**BCC DS**  
**RECEIVED**  
08-MAY-2026  
**APPLICATION REF**  
A007020190

DA Set - 21.02.2024.

DA Set - 15.02.2026.

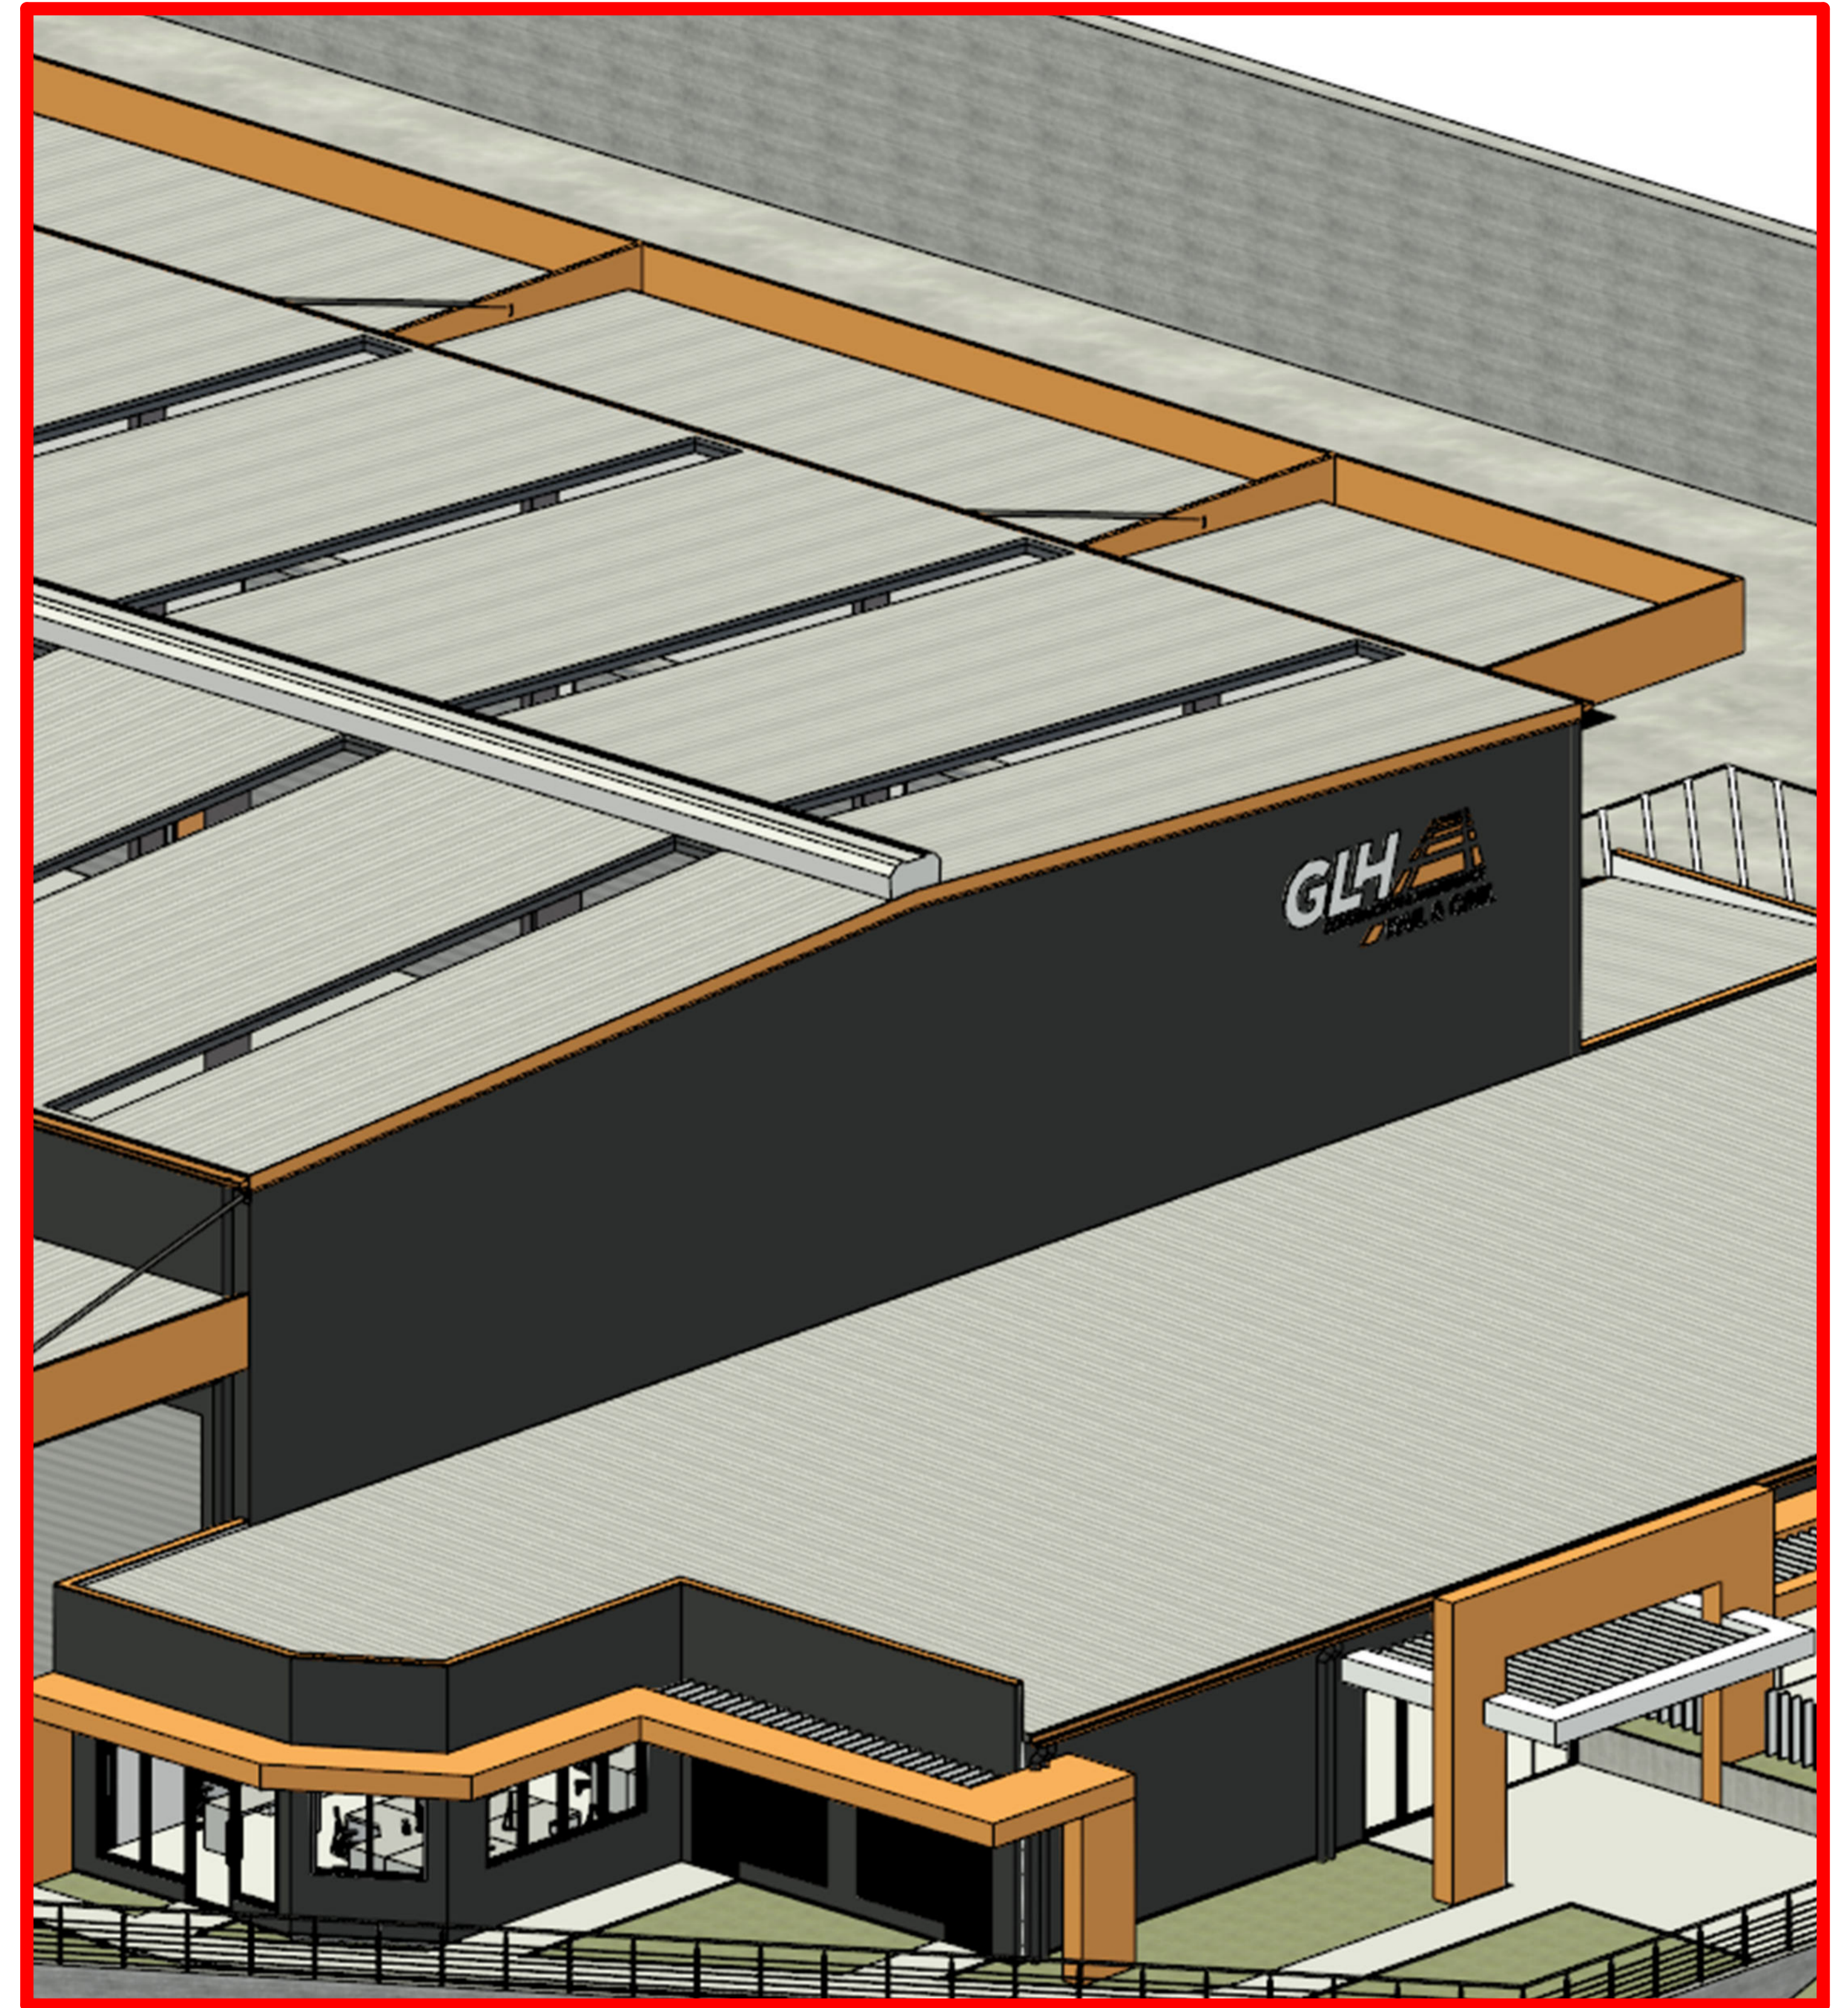
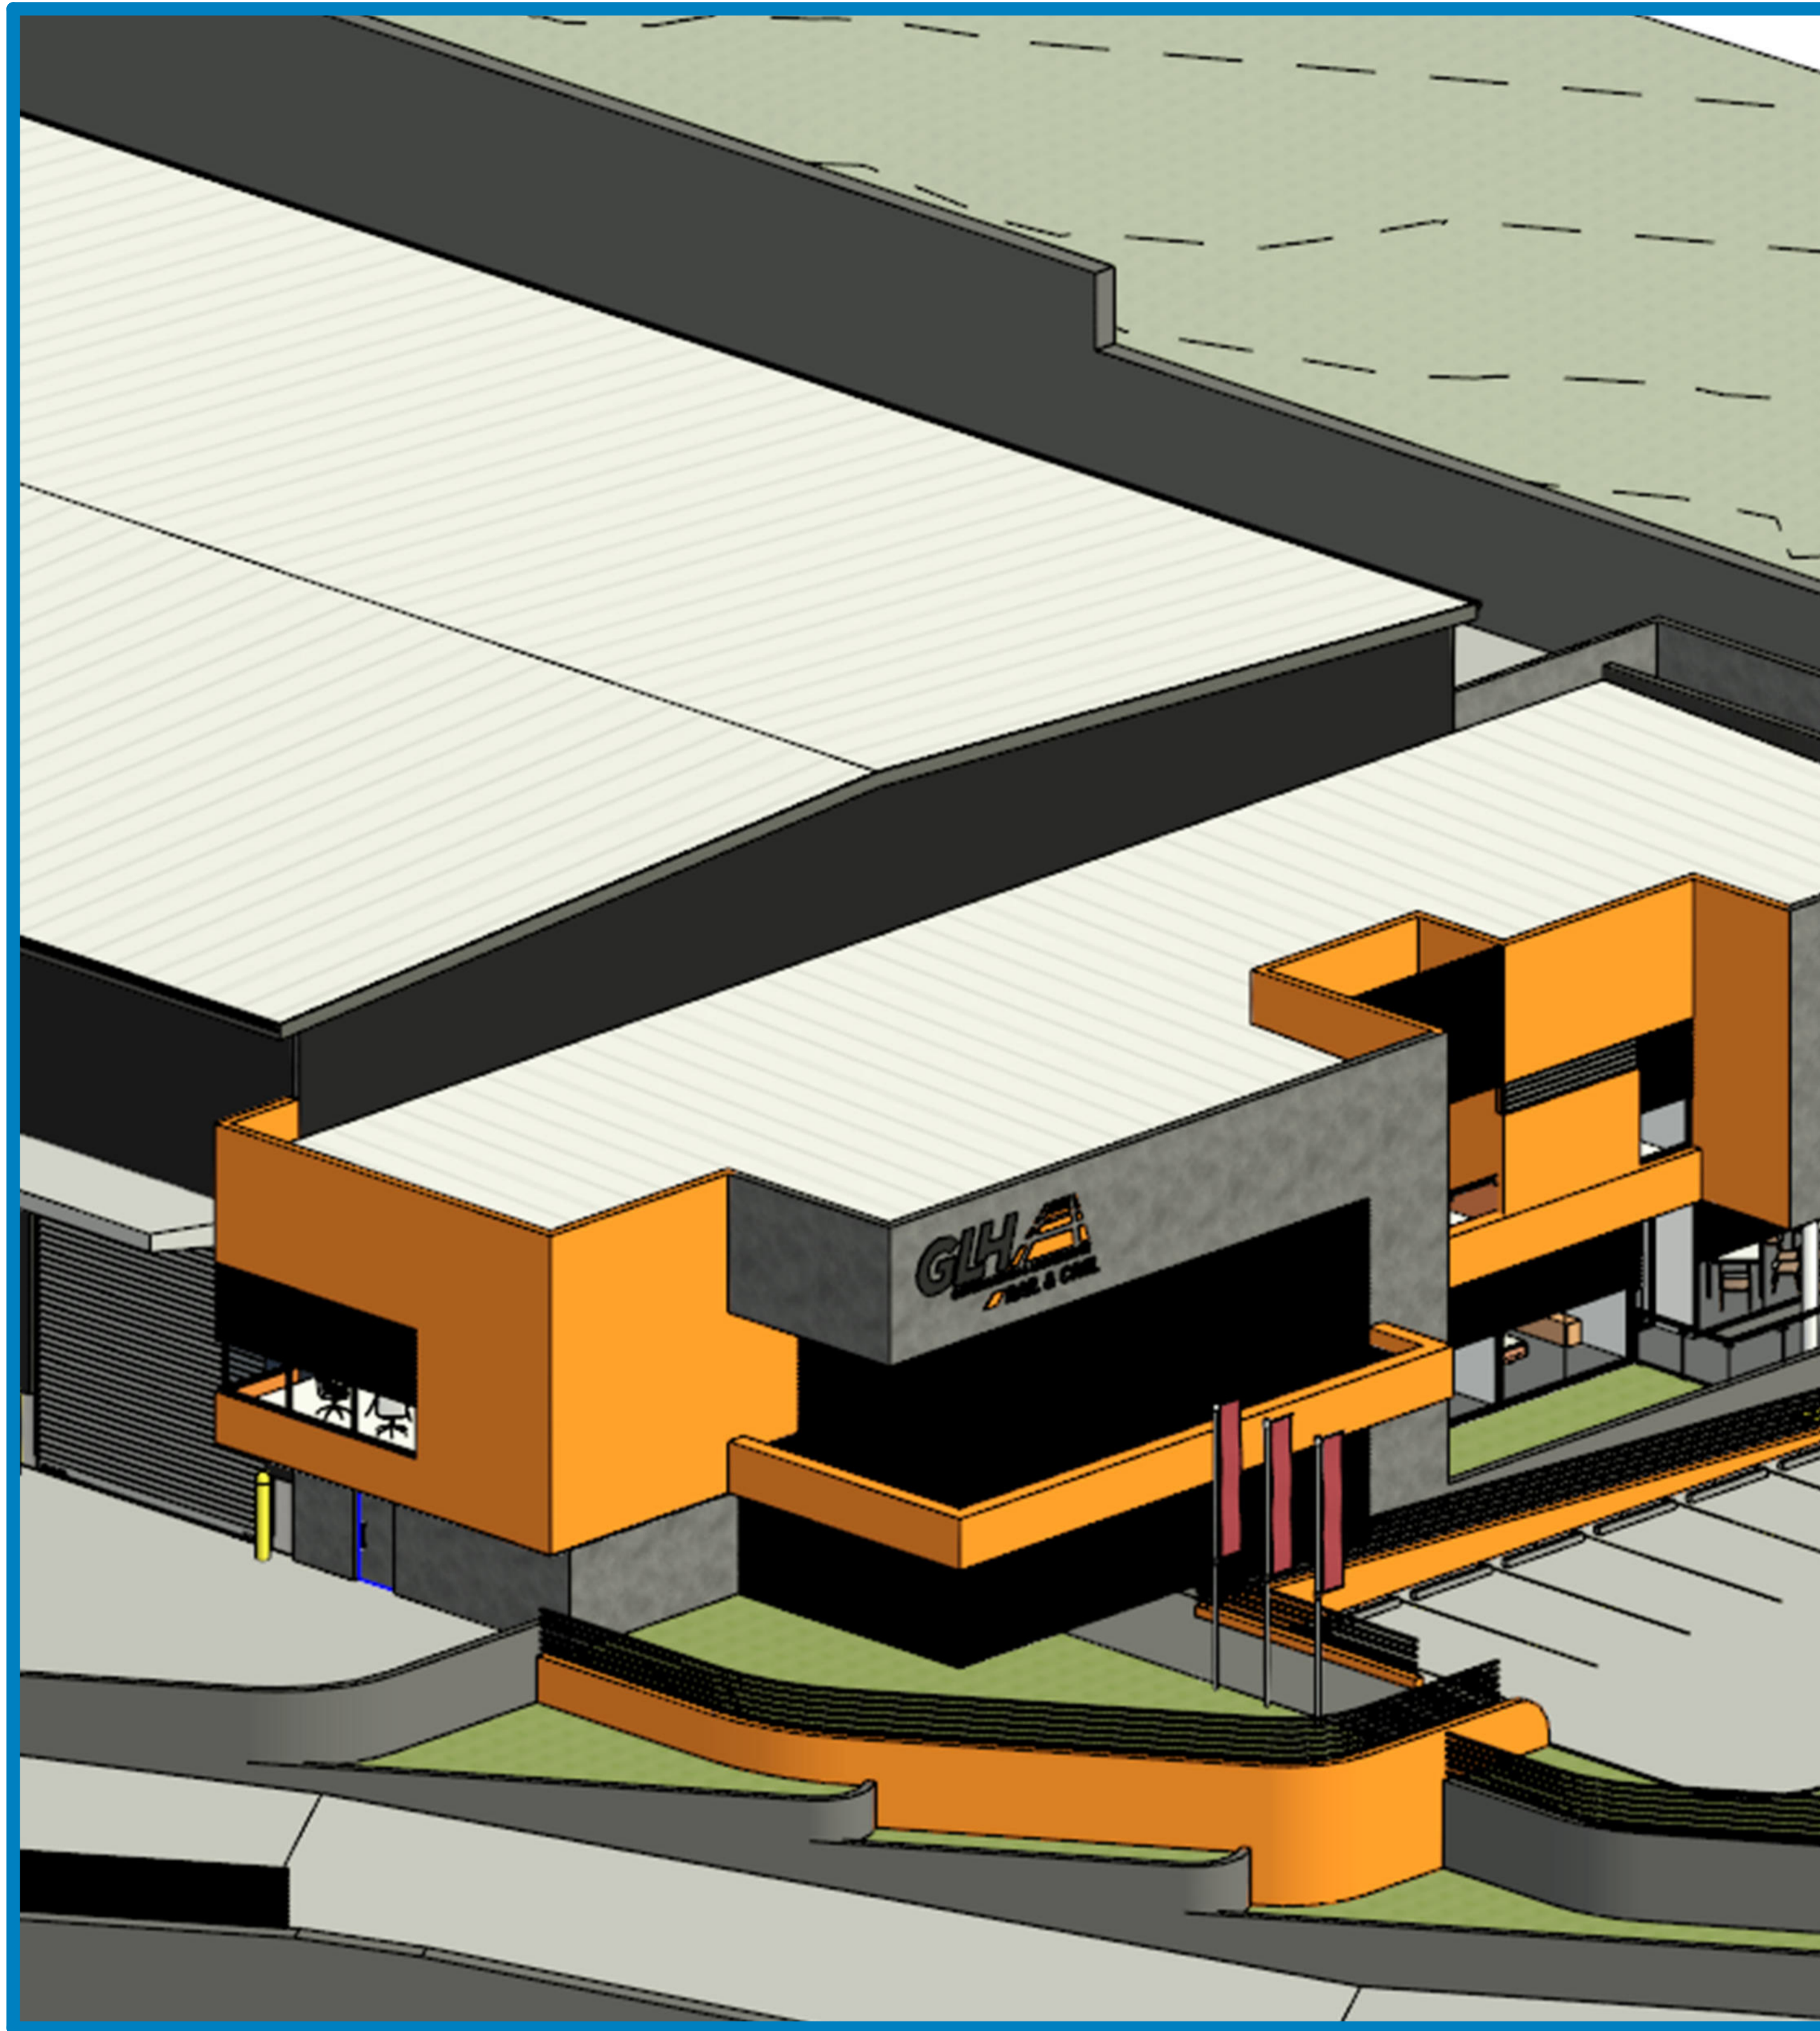
04. Ridge ventilation has been added to the warehouse roof.

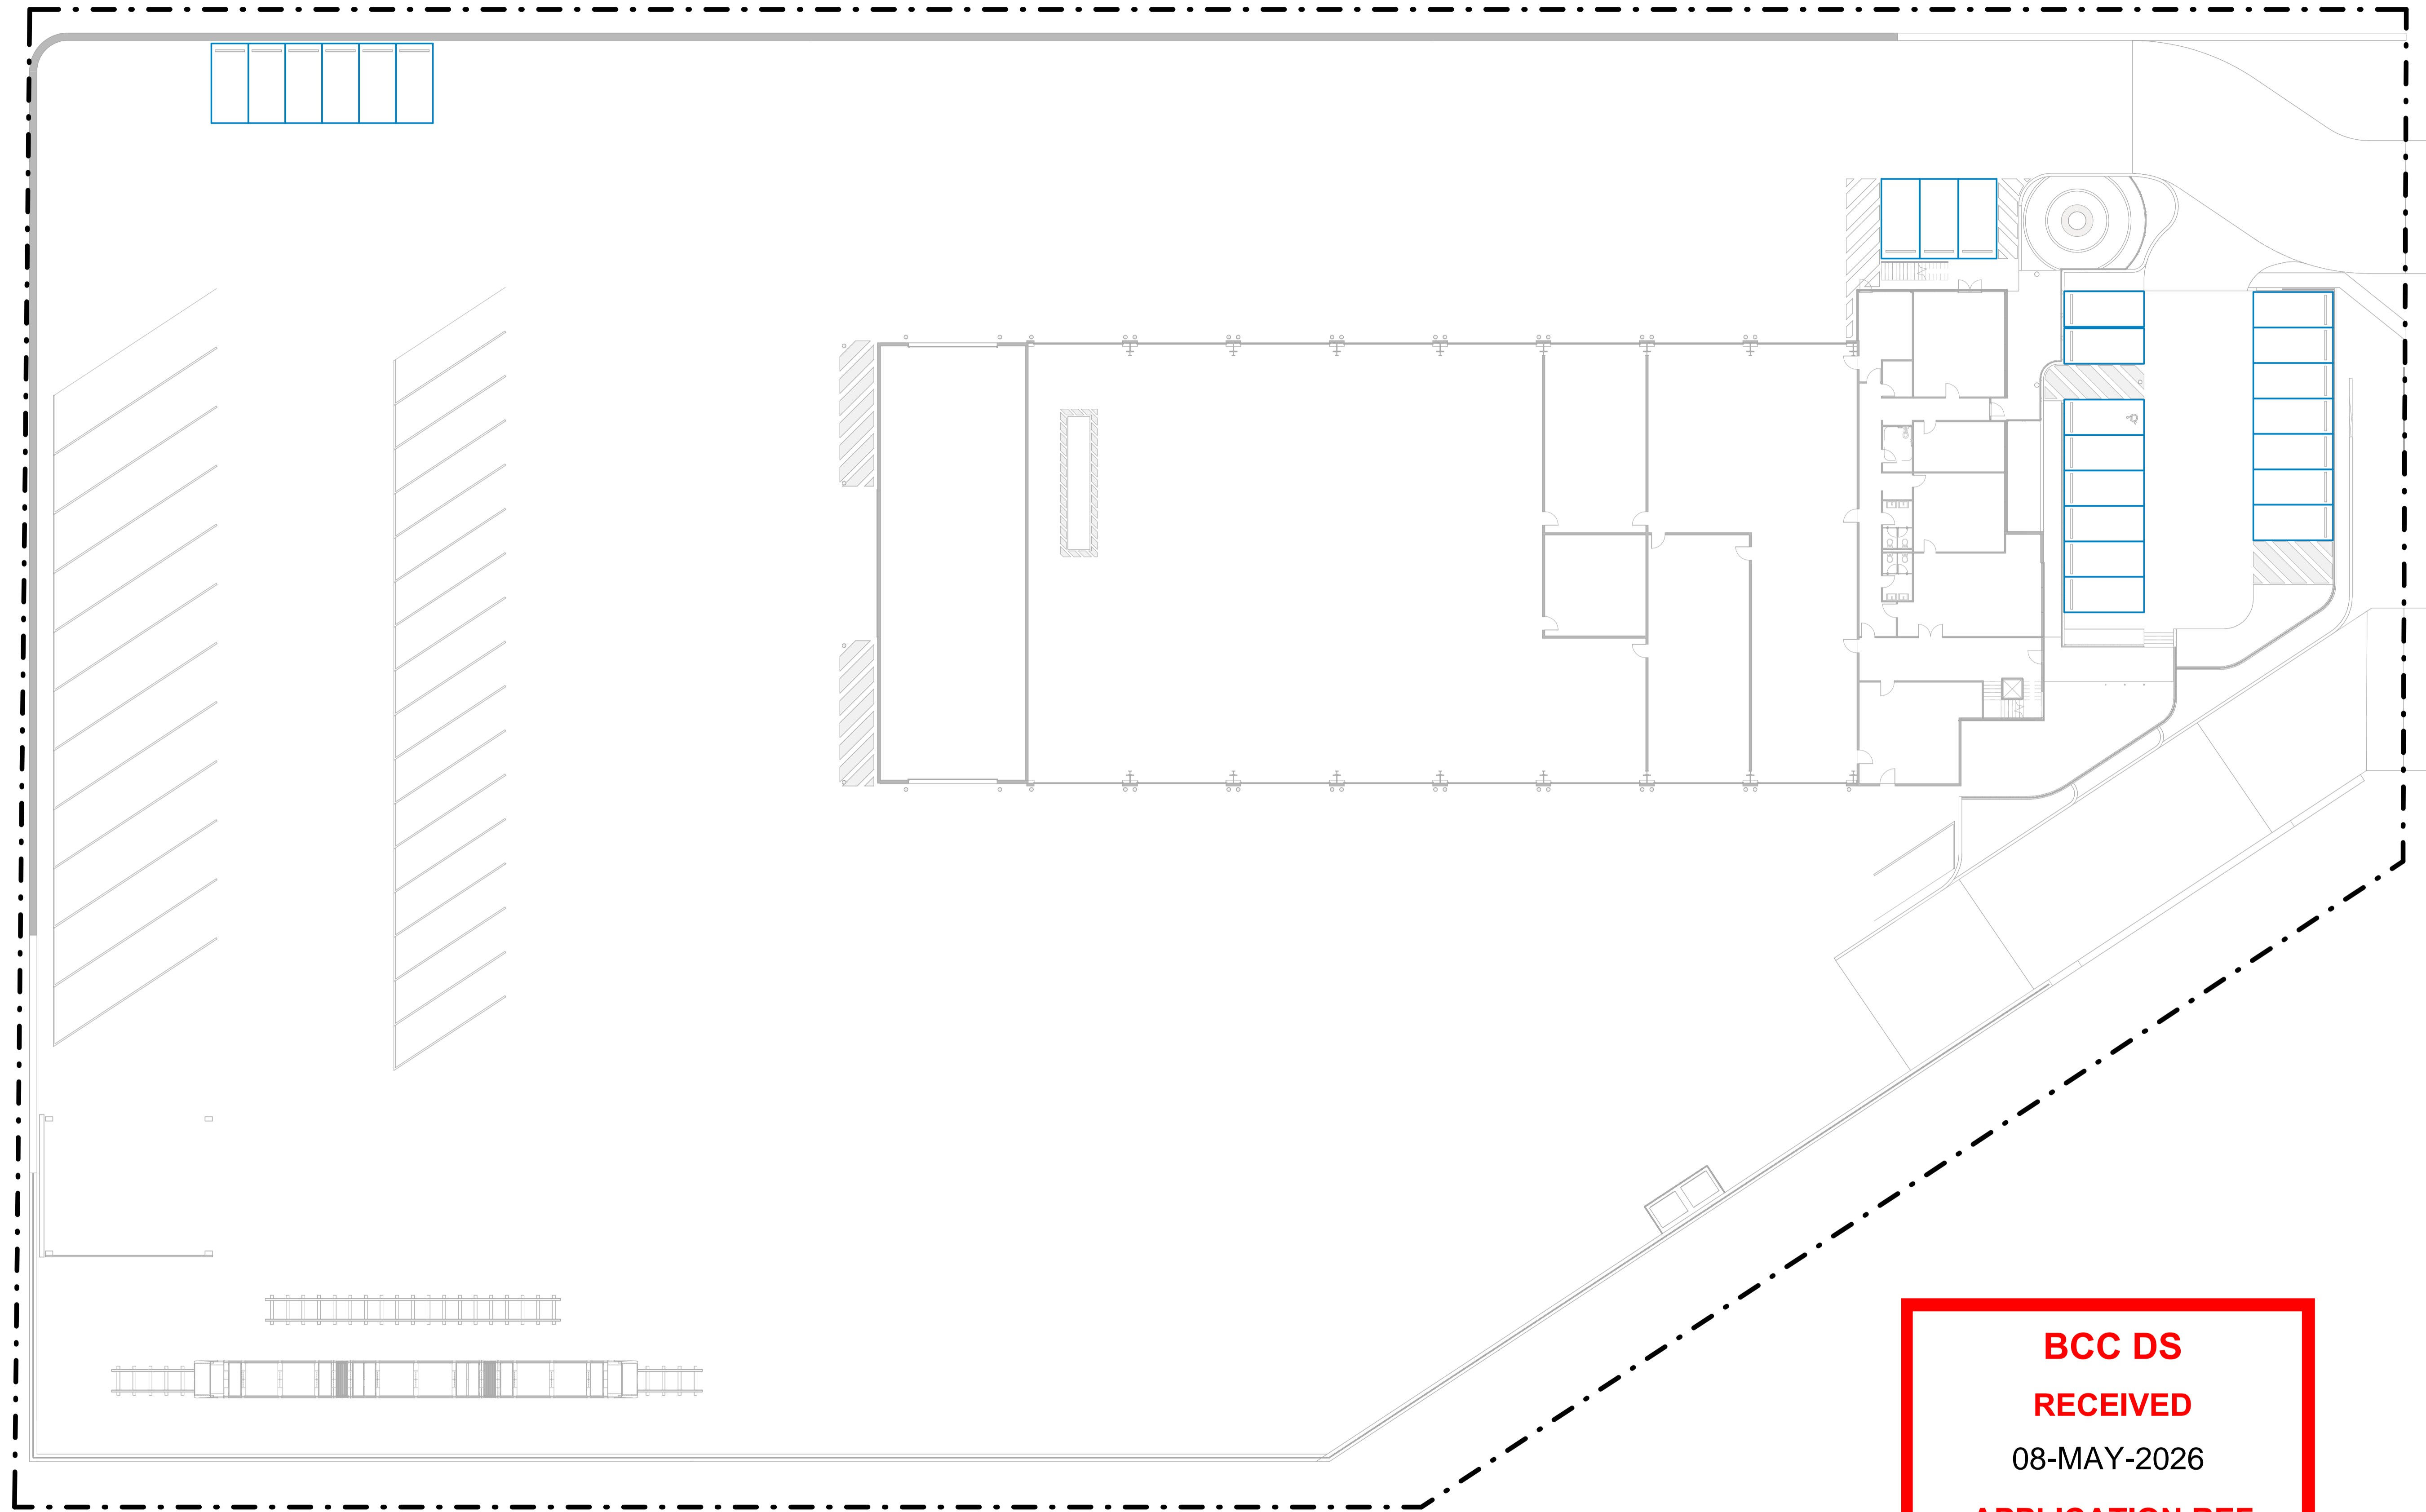
06. The number of car parking spaces has increased.
